IBC — General

2018 GROUP A PUBLIC COMMENT AGENDA

2018 Public Comment Agenda

3114.8.5.3(1)
Bracing Unit Distribution--Maximum Linear Length

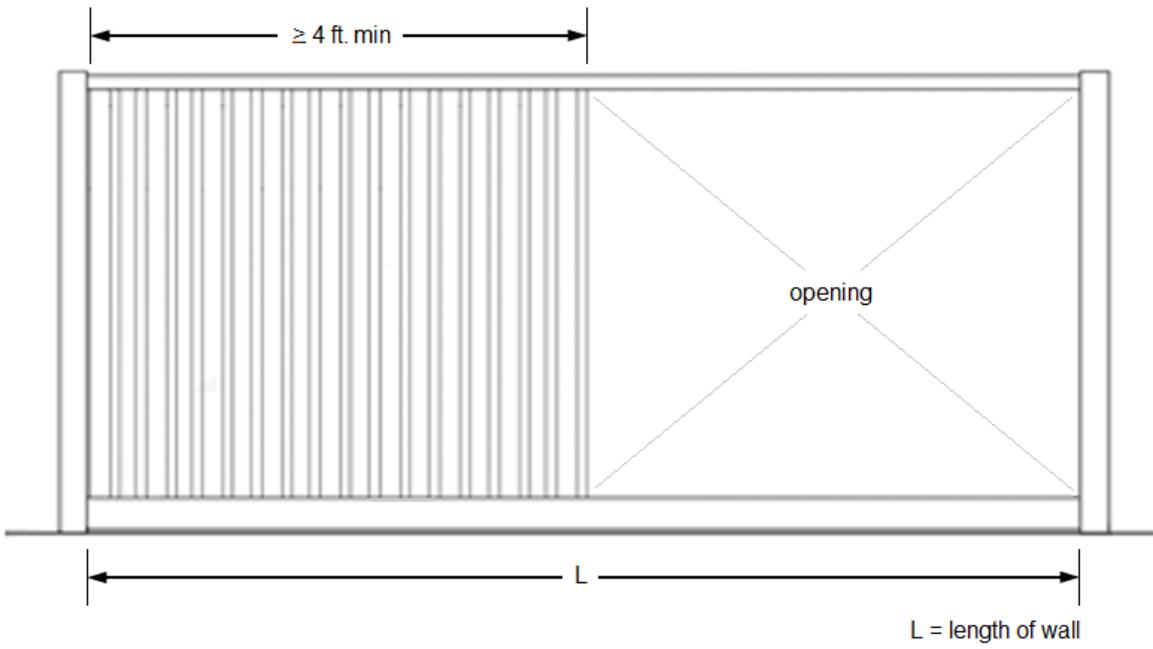
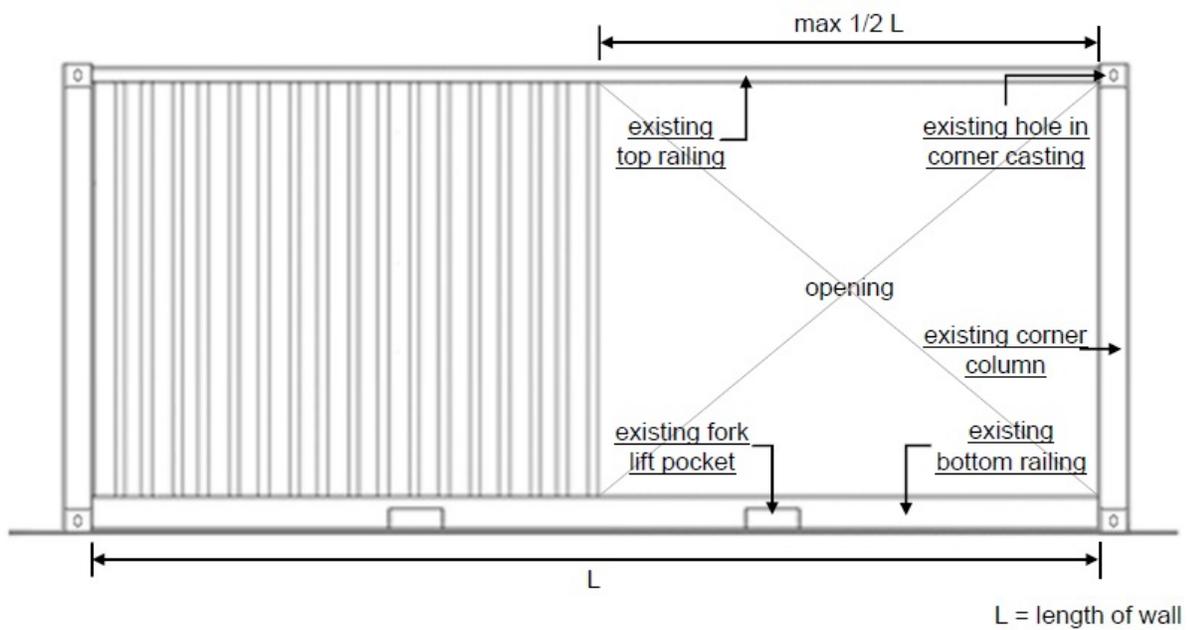
Figures 3114.8.5.3 (1) through (4) - It was brought to our attention that it may be beneficial to identify parts of the intermodal shipping container more clearly rather than use a simple line drawing figure. This is for the benefit of the user to more readily recognize existing conditions versus the permissible cut-aways as allowed by Section 3114.8.5.3. In response we are proposing to add identifying text (the rails, lift slots, and holes) to illustrate those existing elements that are part of the manufacture of intermodal shipping containers.

1. The total linear length of all openings in any individual side walls or end walls shall be limited to not more than 50% of the length of that side walls or end walls, as shown in Figure 3114.8.5.3(1).
